MONTGOMERY COUNTY HISTORIC PRESERVATION COMMISSION
STAFF REPORT

Address:	7129 Maple Avenue, Takoma Park	Meeting Date:	9/3/2025
Resource:	Non-Contributing Resource Takoma Park Historic District	Report Date:	8/27/2025
Applicant:	Brian Levy (Robert Timbers, Agent)	Public Notice:	8/20/2025
Review:	HAWP	Tax Credit:	Yes
Permit No.:	1128802	Staff:	Laura DiPasquale
Proposal:	Window replacement

Figure 3: Exterior photographs keyed to the window drawings.

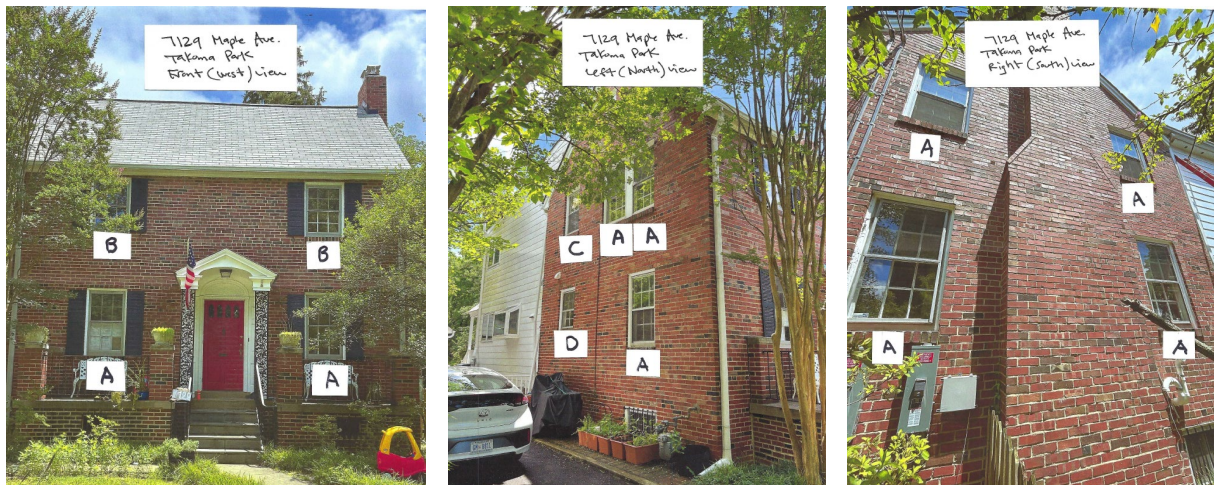
The applicant proposes to remove and replace 13 front and side wood windows with new Marvin Elevate fiberglass-clad six-over-six simulated-divided-lite windows with 7/8" interior and exterior muntins with spacer bars. The existing wood brickmold and nosing is to remain uncapped.

Staff finds that the use of simulated-divided-light fiberglass windows with traditional configurations in original openings is compatible for use on this Non-Contributing resource, per Chapter 24A-8(b)(2), and notes that the HPC typically approves substitute materials for windows and doors on Non-Contributing resources. A recent example includes the HPC’s approval of vinyl windows for the second-floor addition on the Non-Contributing resource at 7329 Baltimore Avenue, Takoma Park, with HAWP 1121582.
